HISTORIC AND DESIGN REVIEW COMMISSION

HDRC CASE NO: 2019-011
ADDRESS: 410 N OLIVE ST
LEGAL DESCRIPTION: NCB 578 BLK D LOT 2
ZONING: RM-4
CITY COUNCIL DIST.: 2
DISTRICT: Dignowity Hill Historic District
APPLICANT: Jason Beltran
OWNER: Jason Beltran
TYPE OF WORK: Installation of front yard fencing
APPLICATION RECEIVED: January 04, 2019
60-DAY REVIEW: March 05, 2019
REQUEST:

The applicant is requesting a Certificate of Appropriateness for approval to construct a front yard fence.

PLOT PLAN
FOR BUILDING PERMITS

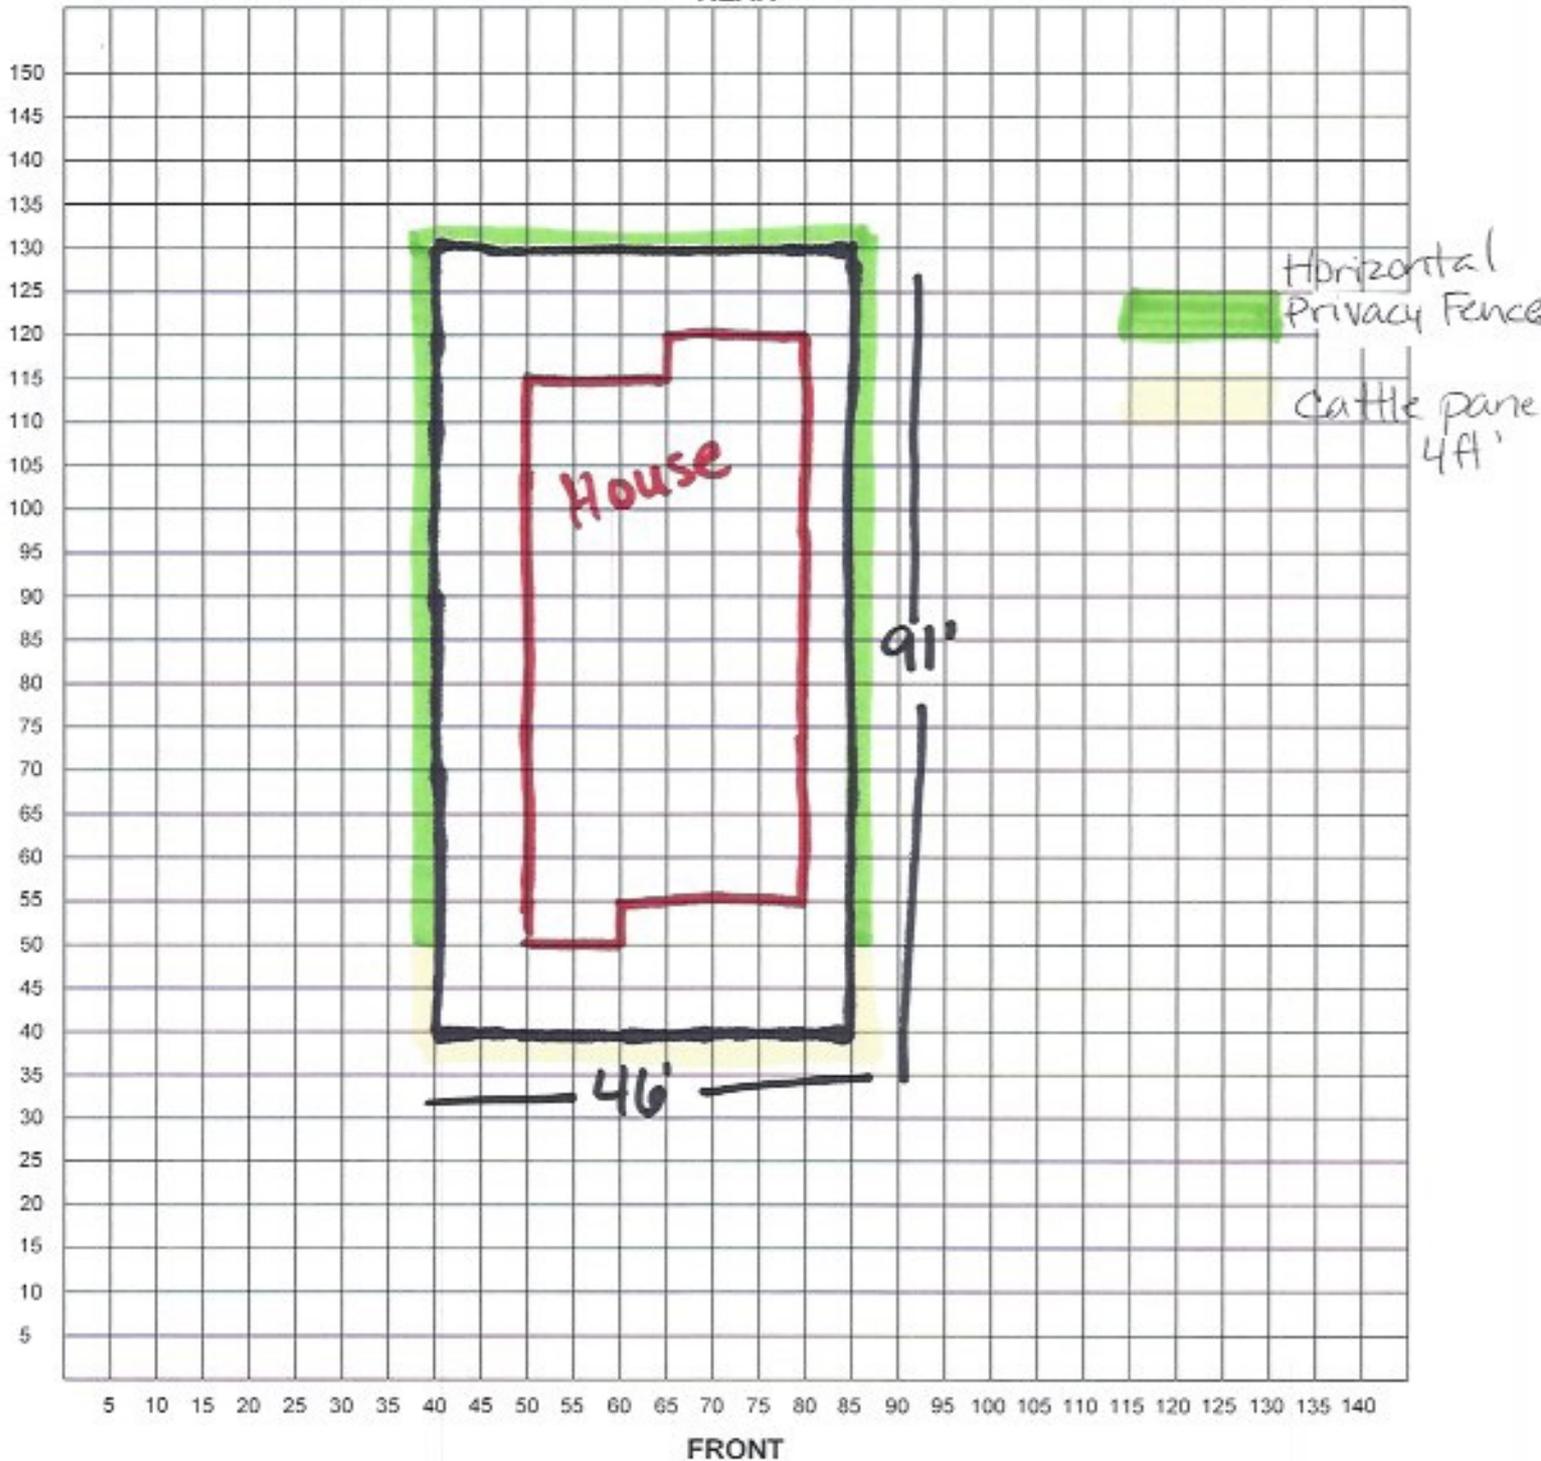
- a 4-foot tall cattle panel front yard fence that spans across the front driveway.
- b. FENCE LOCATION – The applicant has proposed to install a new front yard fence. Based on the submitted site plan and the construction documents approved at the June 6, 2018, HDRC hearing, the fence will span across the driveway. According to the Historic Design Guidelines, new front yard fences should follow historic fence placements in the district. Staff finds that the fence should turn at the driveway to meet the corner of the structure, rather than spanning across the driveway as proposed. Staff also finds that the driveway gate, if included, should be set back behind the front façade plane of the structure. Finally, staff finds that a separate fence segment, if desired, can be placed on the north side of the driveway.

- i. That the fence turn at the driveway to meet the corner of the structure and the driveway gate, if included, be set back behind the front façade plane of the structure, as noted in finding b. If desired, a separate fence segment can be placed on the north side of the driveway, as also noted in finding b.
- ii. That the fence be a maximum of four feet in height. The final construction height of an approved fence may not exceed the maximum height as approved by the HDRC at any portion of the fence. Additionally, all fences must be permitted and meet the development standards outlined in UDC Section 35-514.
